THM 3T40 (125C) NO REVERSE AND/OR PREMATURE LOW/REVERSE CLUTCH FAILURE

Figure 1

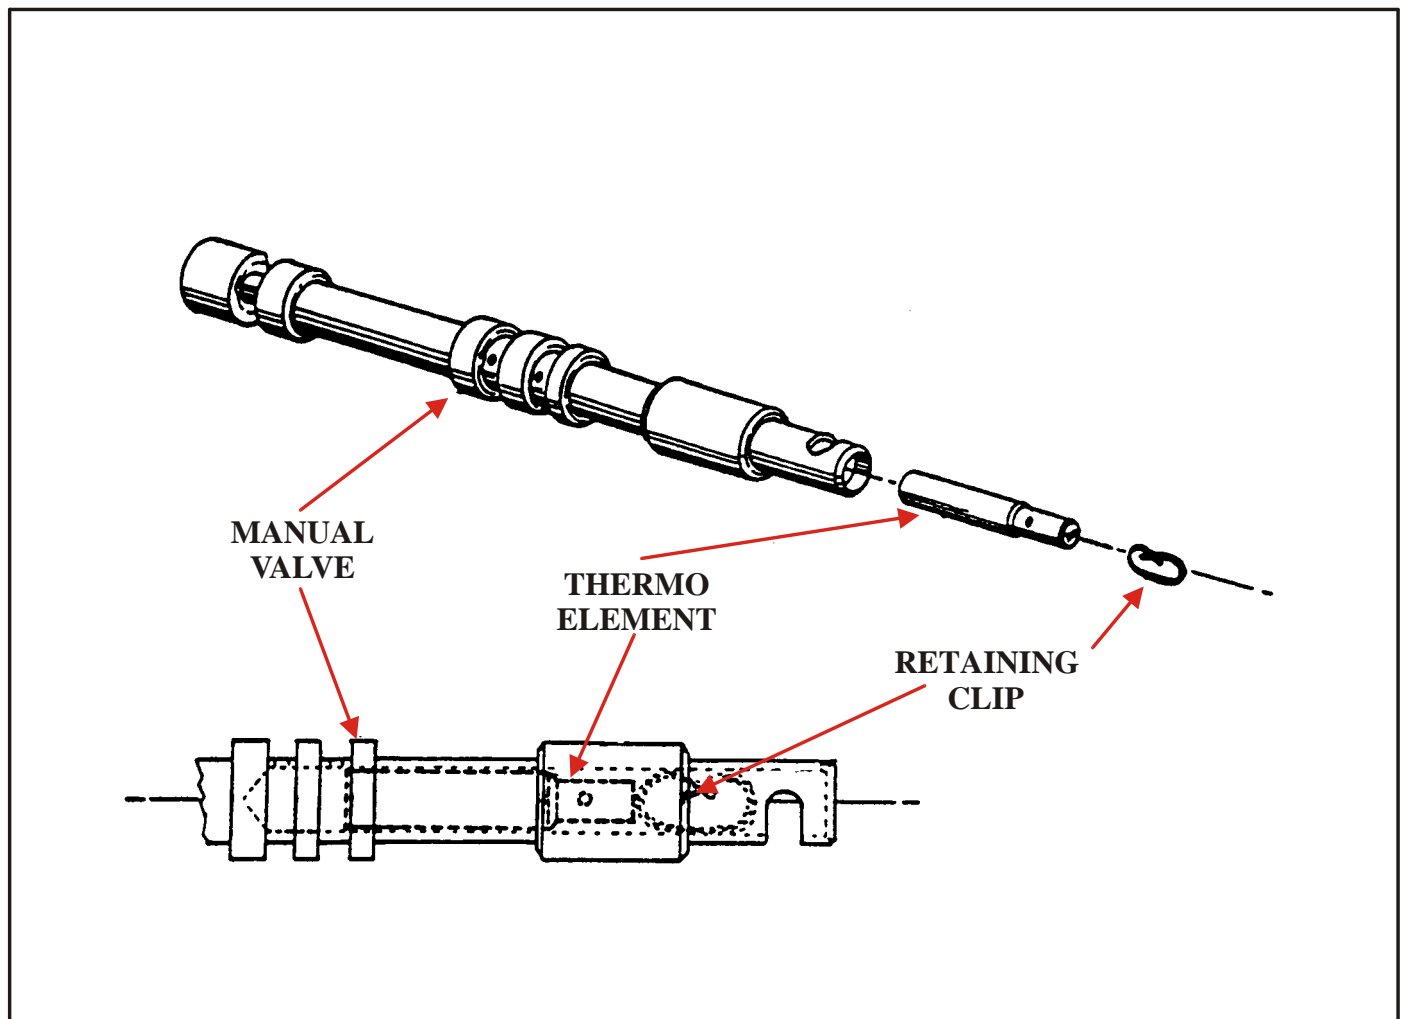
COMPLAINT: A no reverse condition and/or low/reverse clutches badly burnt at a very low mileage.

CAUSE: The cause may be the Low/Reverse fluid not completely exhausting, so that the Low/Reverse clutch remains partially applied while moving in all forward gears. All reverse fluid must exhaust through the thermo element, located in the manual valve, on a reverse to drive garage shift.

CORRECTION: Remove and discard the thermo element and the retaining clip, located inside the manual valve, on all vehicles so equipped (See Figure 1). This should be done as standard procedure during ALL rebuilds.
